SB, Slip Clutch, DM220, DM230, 2015-01

SYMPTOM/DESCRIPTION

Figure 1: Showing affected spare parts. Note that the bushing and gearwheel (16) are not affected.

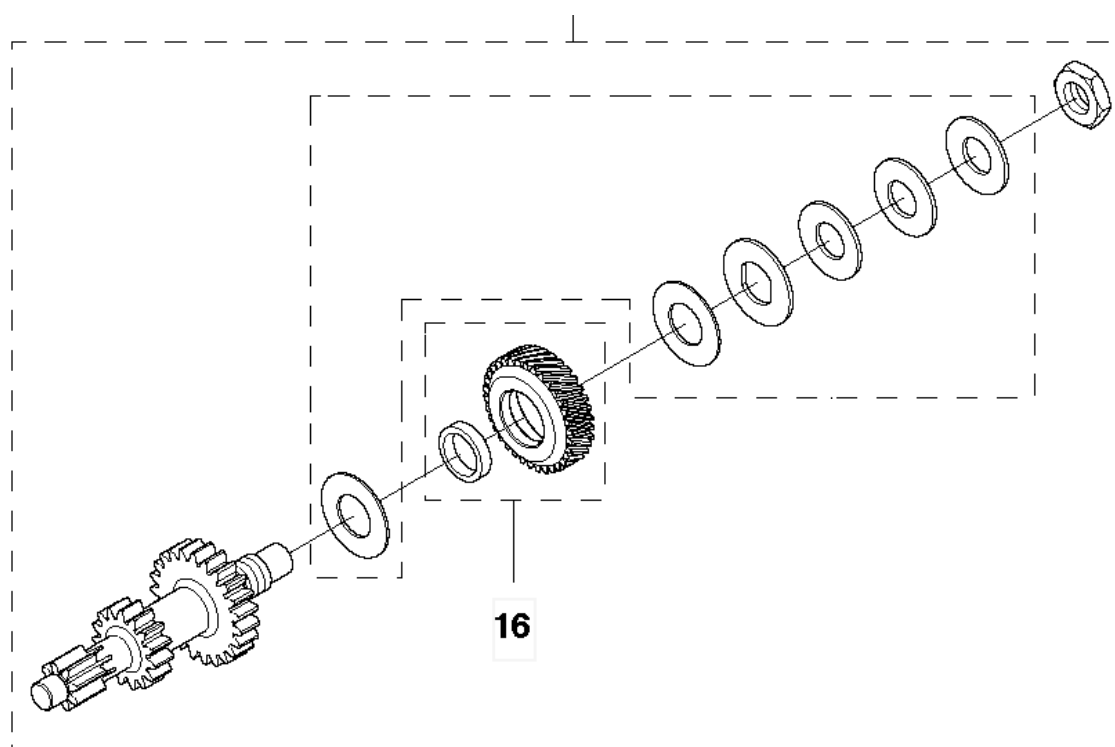
Parts for the slip clutch in DM220 and DM230 have been updated. Older parts have shown to give occasional problems with gearwheel wear and slip clutch endurance. This will affect the complete assemblies as well as the “wear and tear” parts.

When repairs are carried out on products produced later than the communicated serial numbers, the clutch wear and tear parts article number below can be used, otherwise there is a need to change the complete slip clutch assy.
